TRANSMITTAL OF VARIANCES TO PROJECT SPECIFIC PLANS

This letter transmits for your records, variances to the following Project Specific Plans (PSP): PSP for Lead Delineation in the Area 2 Phase 1 Firing Range; PSP for Sampling of Soil Stockpile 5 for On-Site Disposal Facility (OSDF) Waste Acceptance Criteria (WAC) Attainment; Area 8 Phase 1 Certification Sampling, Rev 1; and the Certification of Area 1 Phase II Sector 1, Sector 2A, and Conveyance Ditch, Rev 2. The variances do not involve a significant change in scope.

VARIANCE / FIELD CHANGE NOTICE

PROJECT TITLE: PSP for Sampling of Soil Stockpile 5 for OSDF WAC Attainment

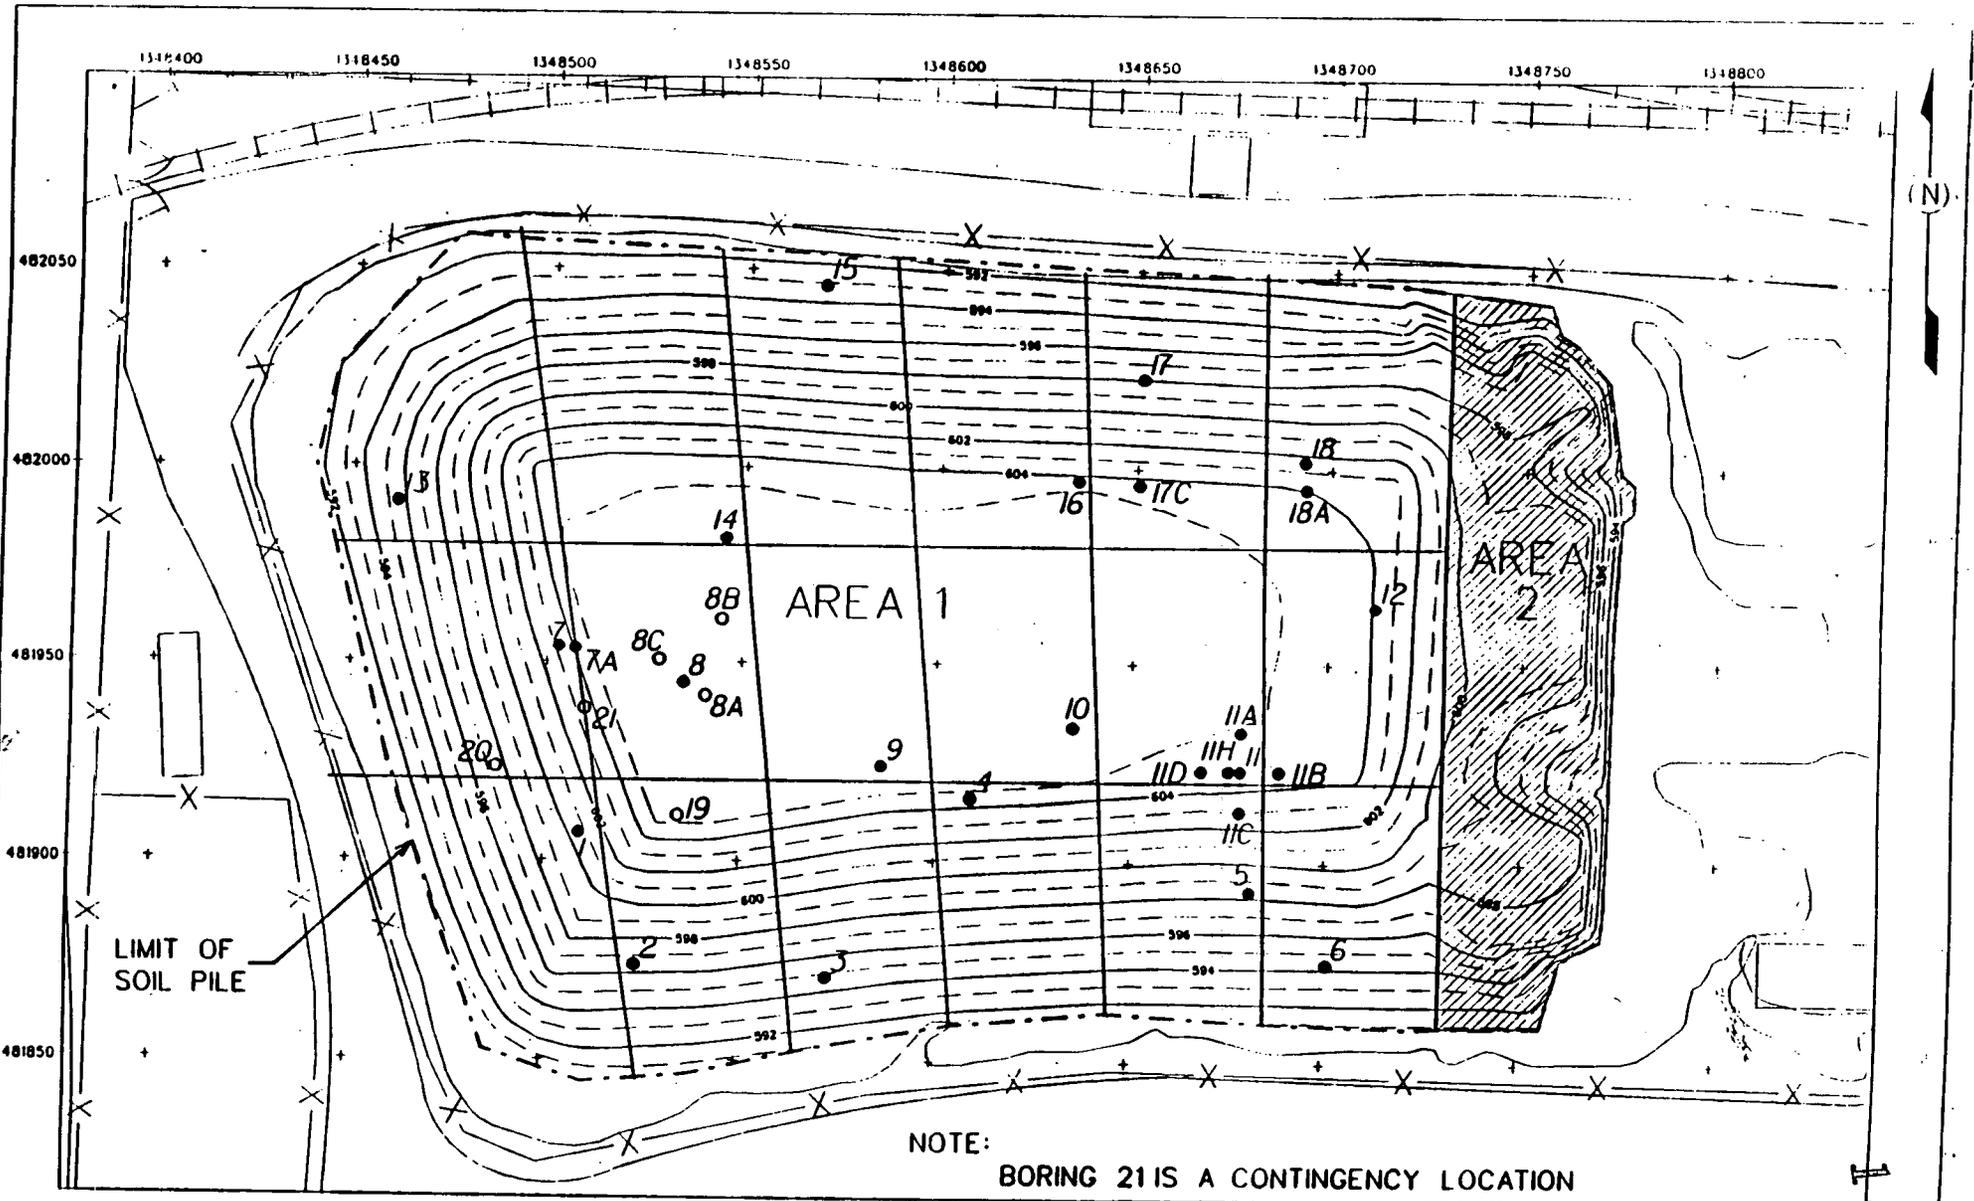
This variance describes additional samples to be collected from SP5 as stated in the PSP (Section 1.4) if above-WAC soils are encountered. Above-WAC soil for total uranium was detected in boring locations 1 and 8 of SP5 during the first round of sampling per the PSP as follows:

Additional borings will be located to encompass a triangular-shaped sector in the southwest corner of SP5 in order to bound the above-WAC soil horizontally and vertically. Five borings and one contingency location have been selected for soil coring and field screening as illustrated in Figure 2-2 attached.

Soil cores will be collected for the entire height of the pile at each of the five borings (and possibly contingency location 21) and each core will be surveyed with a beta-gamma probe (frisker). Any soil interval ≥ 100 ccpm will be collected by removing a 6-inch interval (bounding the ≥ 100 ccpm area) for total uranium analysis (TAL 50.03.52.03-B) per the PSP. As stated in the PSP, any debris in the core sample (e.g., concrete, wood, rubber, wire, etc.) that can be separated will be removed from the sample prior to containerizing.

An archive soil sample will be collected from each of the five borings at the 597.1 feet elevation and archived for possible future analysis for total uranium. The archive sample intervals are provided below. Also, archive samples will be collected above and below any interval exhibiting ≥ 100 ccpm for possible analysis in the future.

Location	Total Depth (ft.)	Archive Sample Interval	Archive Sample ID
SP5-8A	15.4	8.8' - 9.3'	SP5-8A-1-R
SP5-8B	15.5	8.9' - 9.4'	SP5-8B-1-R
SP5-8C	15.5	8.9' - 9.4'	SP5-8C-1-R
SP5-19	13.5	6.9' - 7.4'	SP5-19-1-R
SP5-20	7.1	0.4' - 0.9'	SP5-20-1-R
SP5-21	14.7	8.1' - 8.6'	SP5-21-1-R

(SP5-21 will only be completed if Location 8C or 20 exhibit >100 ccpm)

The additional borings are necessary to determine the boundaries of above-WAC (total uranium) soil to be excavated from the pile in the vicinity of boring location SP5-1 and SP5-8. The information is required to design an excavation plan for SP5 to segregate above-WAC soil from below-WAC soil.

ADDITIONAL SOIL SAMPLING LOCATIONS AREA 2, PHASE I FIRING RANGE.

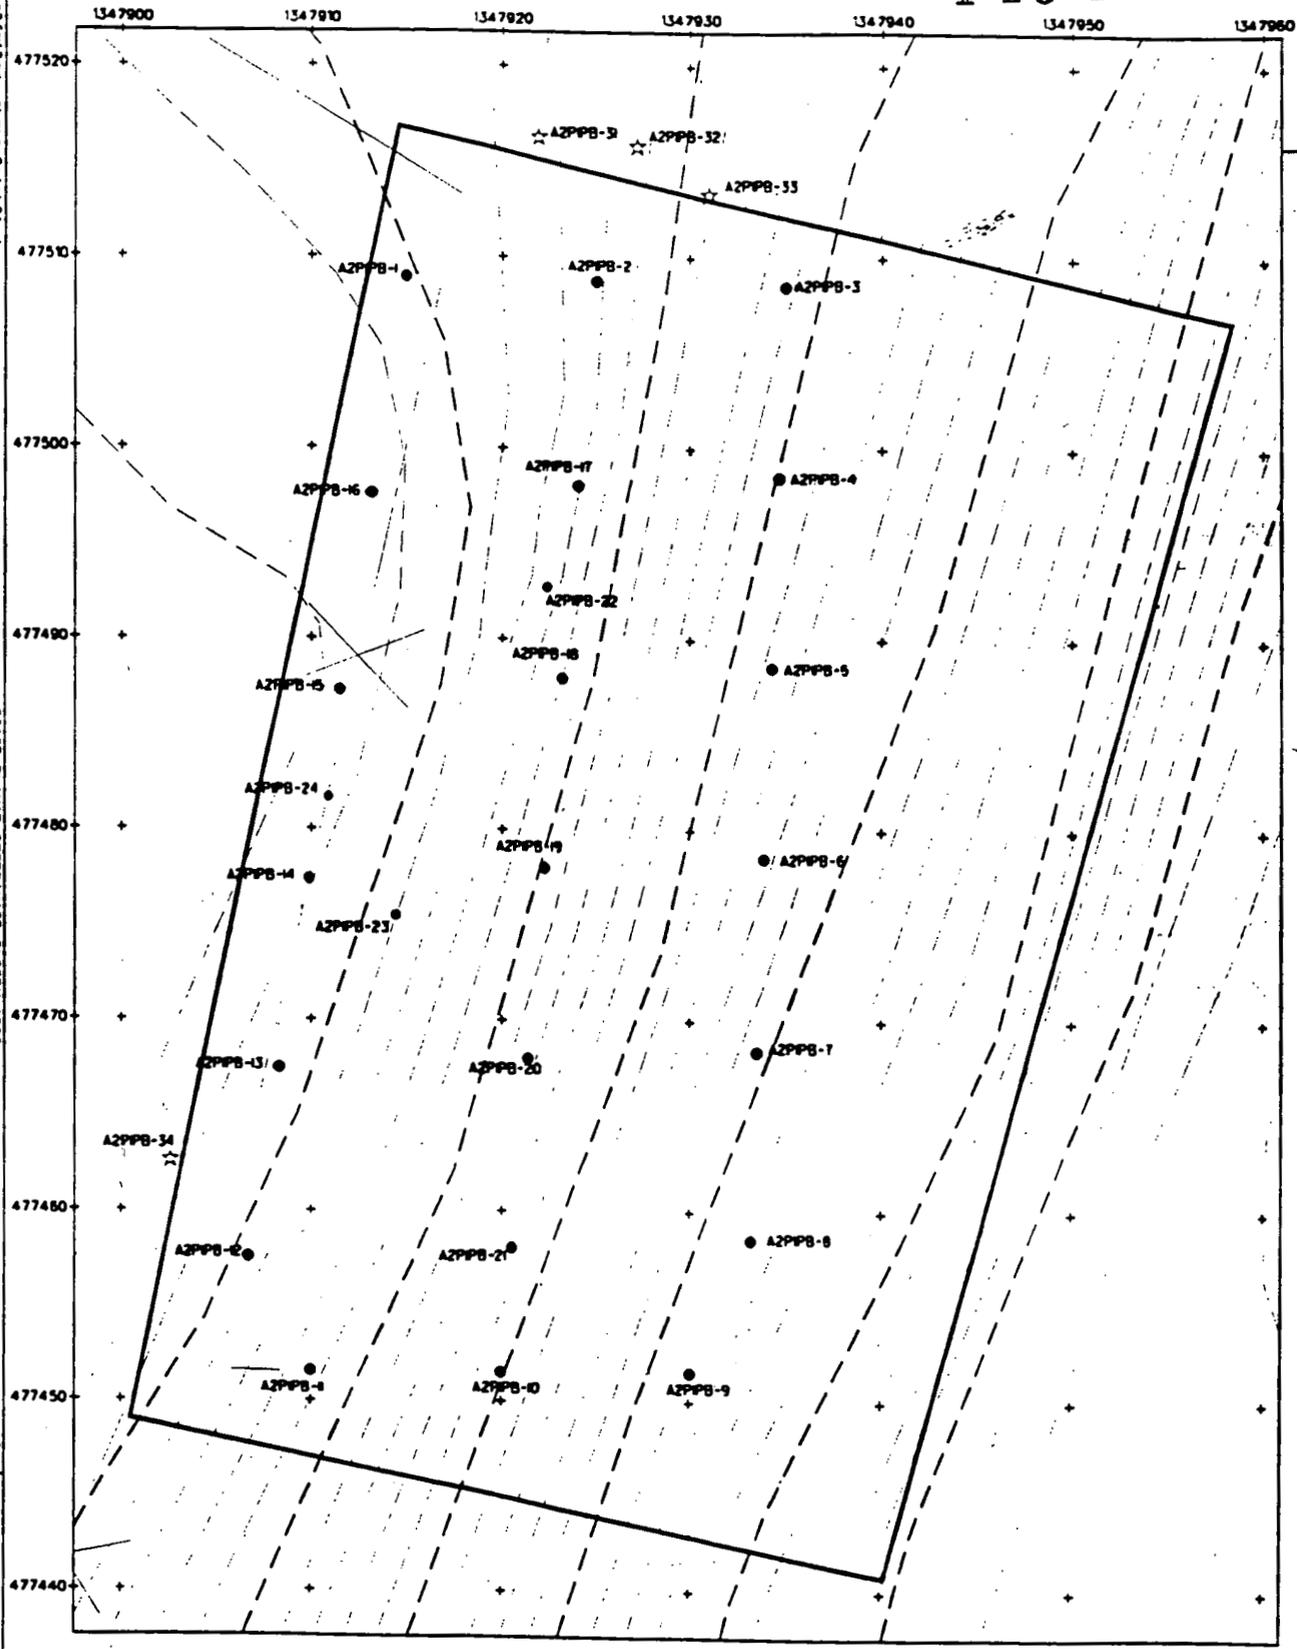
Four additional borings (A2PIPB-31, A2PIPB-32, A2PIPB-33, and A2PIPB-34, see attached map) will be completed in the Area 2, Phase I Firing Range area to bound the limits of soil contamination. Borings will be completed to a depth of 3 feet with samples collected at every 6-inch interval.

Coordinates for the additional sample points are as follows:

- A2PIPB-31 Easting: 1347921.92 Northing: 477516.26
- A2PIPB-32 Easting: 1347927.15 Northing: 477515.82
- A2PIPB-33 Easting: 1347930.99 Northing: 477513.32
- A2PIPB-34 Easting: 1347902.38 Northing: 477462.74

Justification: Per Section 1.2 of the PSP, and at the request of the Ohio Environmental Protection Agency, additional soil samples may be collected.

FIGURE 7. AREA 8, PHASE 1 CERTIFICATION SAMPLING LOCATIONS

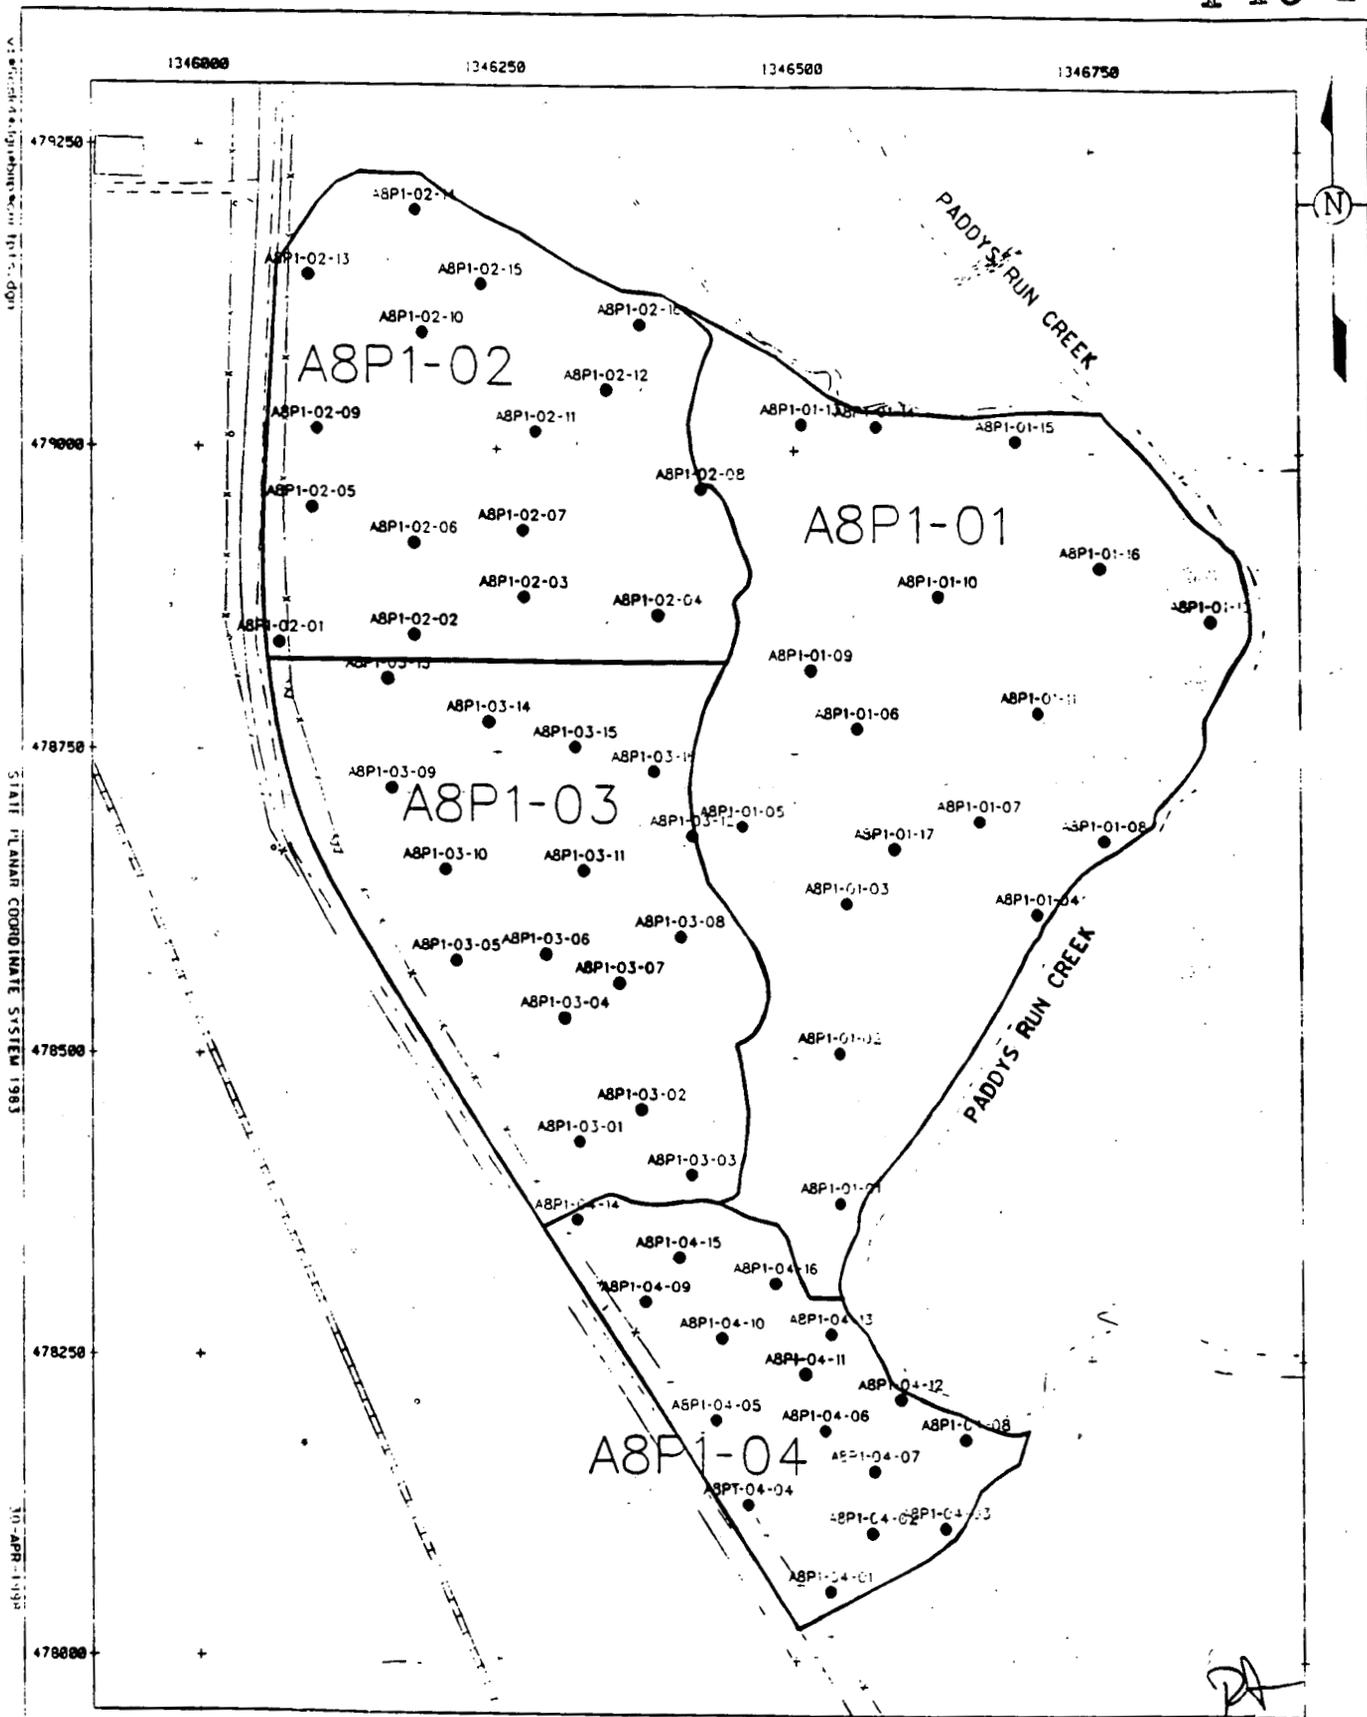
As a result of U.S. EPA comments, two A8PI certification sampling locations have been moved within CU-02, and an additional sample location has been added to CU-01, as follows:

- Sample location A8P1-02-05 is now at Easting = 1346094, Northing = 478951.
- Sample location A8P1-02-14 is now at Easting = 1346181, Northing = 479197.
- A 17th location has been added to CU-01. It is identified as A8P1-01-17, is located at Easting = 1346584, Northing = 478672, and will be submitted for analysis in the same manner as other certification samples. Therefore, 13 samples from CU-01 will be submitted for analysis.

The revised Figure 7 (attached) shows the final certification sampling locations within A8PI, including the above.

A check of the minimum distance criterion failed to identify two sample pairs that did not meet the criterion. Locations A8P1-02-05 and A8P1-02-09 were positioned slightly closer than the minimum distance, as were locations A8P1-02-13 and A8P1-02-14. The above randomly generated sample locations were generated within sub-CUs 05 and 14 of CU-02, and the minimum distance criterion is now satisfied for all certification sampling locations.

Because the pre-certification scan did not include some land within CU-01, an additional certification sampling location has been added within this area to satisfy the concern of the U.S. EPA. This new location also meets the minimum distance criterion.
